June 27, 2024

**RE: Shark Reef Interactive Fountain
ABQ Biological Park
2625 Central Ave. NW
Grading & Drainage Plan
Engineer's Stamp Date: 06/19/2024
Hydrology File: J12D004B**

SHARK REEF INTERACTIVE FOUNTAIN

SITE GRADING & DRAINAGE PLAN

CG-101

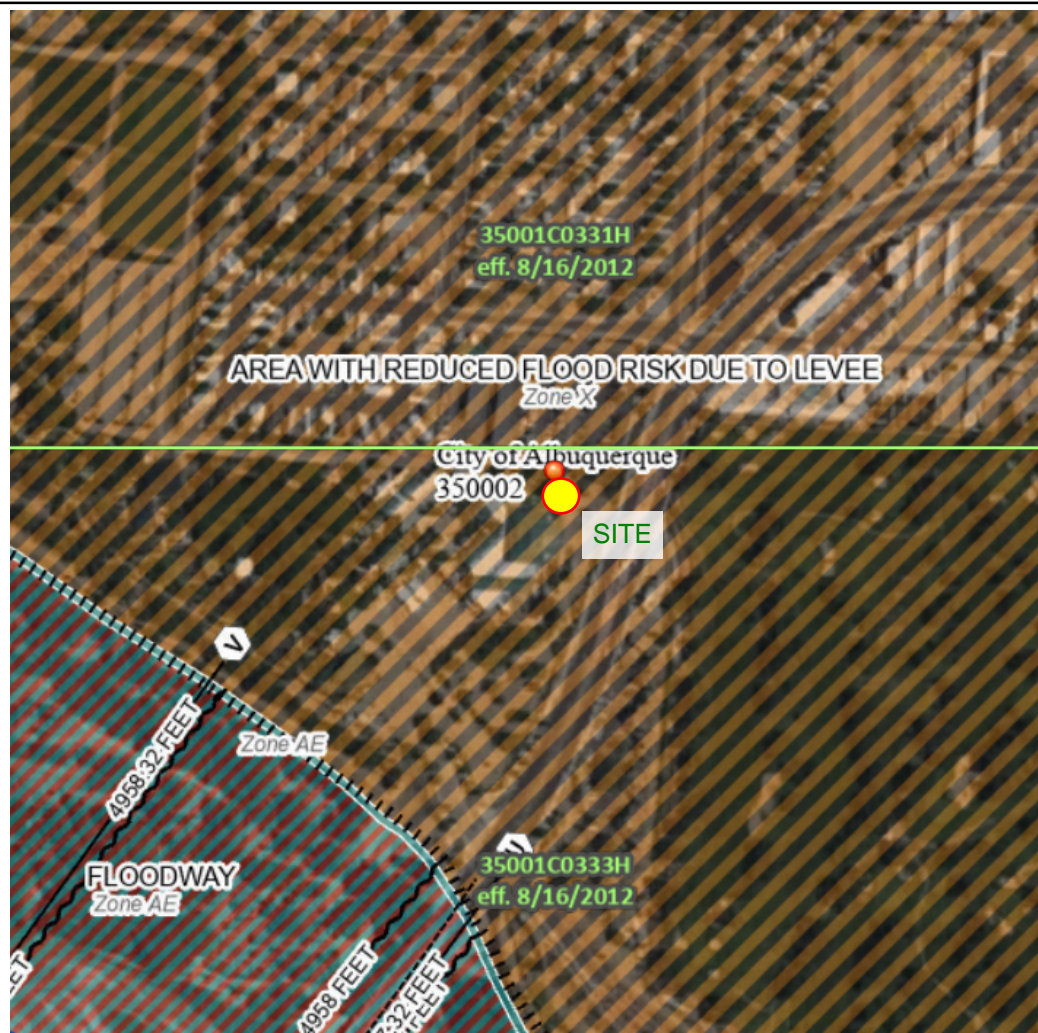
Based upon the information provided in your submittal received 06/20/2024, the Grading & Drainage Plan is approved for Building Permit. Please attach a copy of this approved plan in the construction sets for Building Permit processing along with a copy of this letter.

1. Engineer's Certification, per the DPM Part 6-14 (F): *Engineer's Certification Checklist For Non-Subdivision* is required.
